PLAN COMMISSION MEETING AGENDA

TUESDAY, November 8, 2016 AT 6:00 PM

PROJECT: Plan Review – The Waters Senior Living

PROJECT: Site and Monument Sign Plan Review – Russell Legg, Aurora Health Care

Street Title
PRELIMINARY
LANDSCAPE PLAN

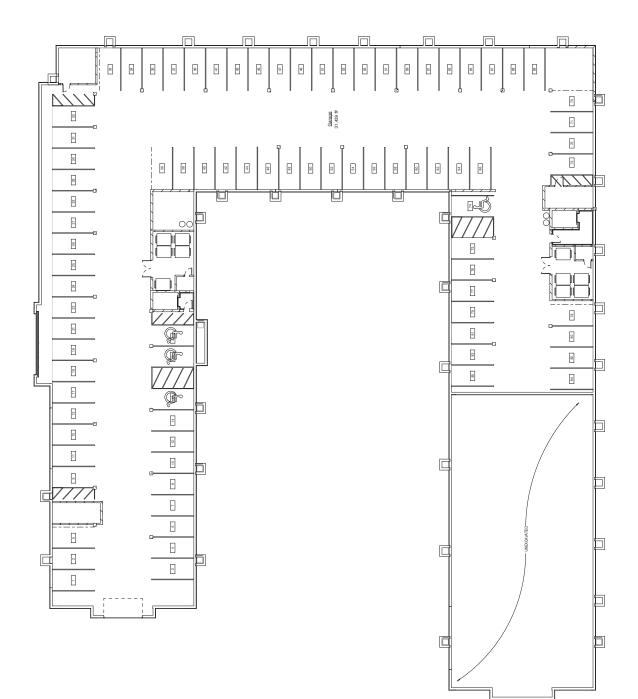
Landscape plans have been submitted showing significant vegetation throughout the site. Staff has provided the Applicant with a copy of the approved landscape plan for the Towne Place Suites hotel to the north for a coordinated landscape treatment along the pedestrian path. Some minor modifications to the landscape plans will be required to incorporate comments received from the City Forester and staff. Unless the Commission directs otherwise, the final landscape plans will be approved by the Director of Community Development prior to the submission of building permit applications.

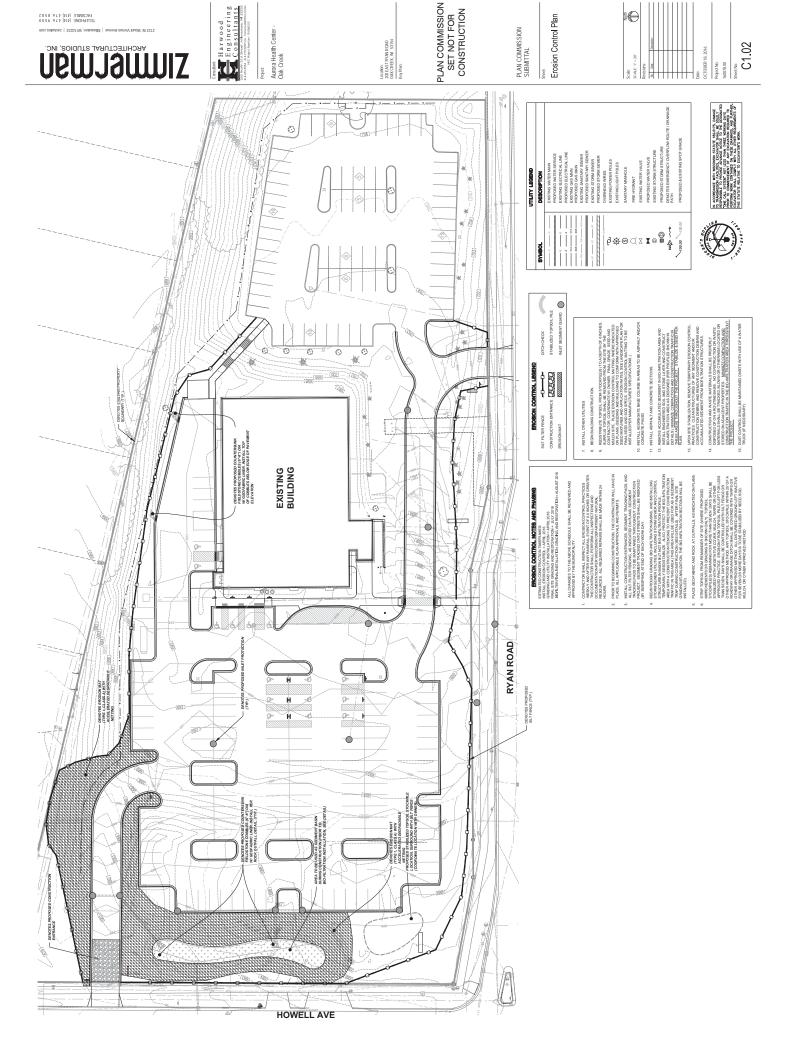
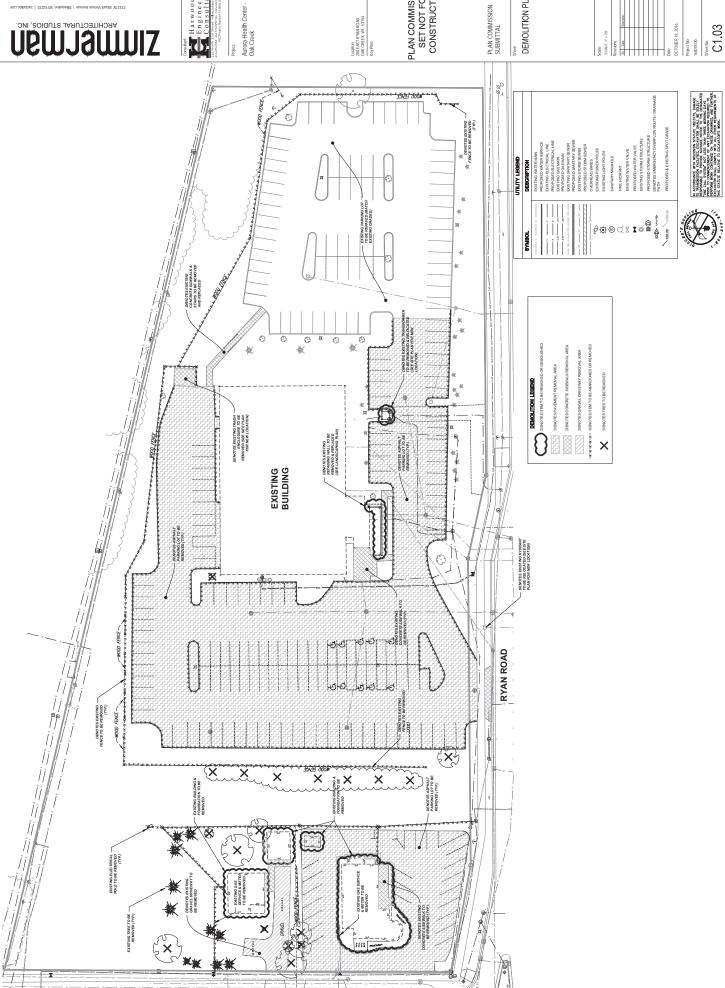
Three (3) directional signs and two (2) monument signs are shown on the site plans. No details for the directional signs have been provided; however, directional signs are limited to a height of 5 feet above grade and no more than 6 square feet in area per side. One design for a monument sign was contained within the submitted plans, but details for the sign itself (materials, illumination, etc.) are missing. Per Section 17.0706(d), ground signs may not exceed 8 feet in height nor 100 square feet per side (max. 200 square feet total), must include address numbers on all sides, must be located a minimum of 10 feet from all property lines and street rights-of-way, and must be located outside of required vision triangles. Electronic message boards are limited to a maximum of 50 square feet. As proposed, the monument sign exceeds the height (16 feet), may exceed the maximum square footage allowance (width dimensions are missing), and the location on Ryan Rd. does not meet required setbacks to the right-of-way. Revised plans are required to be submitted to the Department of Community Development in the conditions of approval above.

Landscaping and stormwater management plans have been submitted; however, additional information is required prior to complete reviews. Comments received from the Water and Sewer Utility and provided to the Applicant's consultants are below:

- 1. Abandon two water and two sewer laterals at the main in Howell Avenue.
- 2. Abandon one unused sanitary sewer lateral at the main in Ryan Road.
- 3. Move existing fire hydrant in proposed driveway on Ryan road to the east to mitigate the conflict.
- 4. No trees planted above the water main.
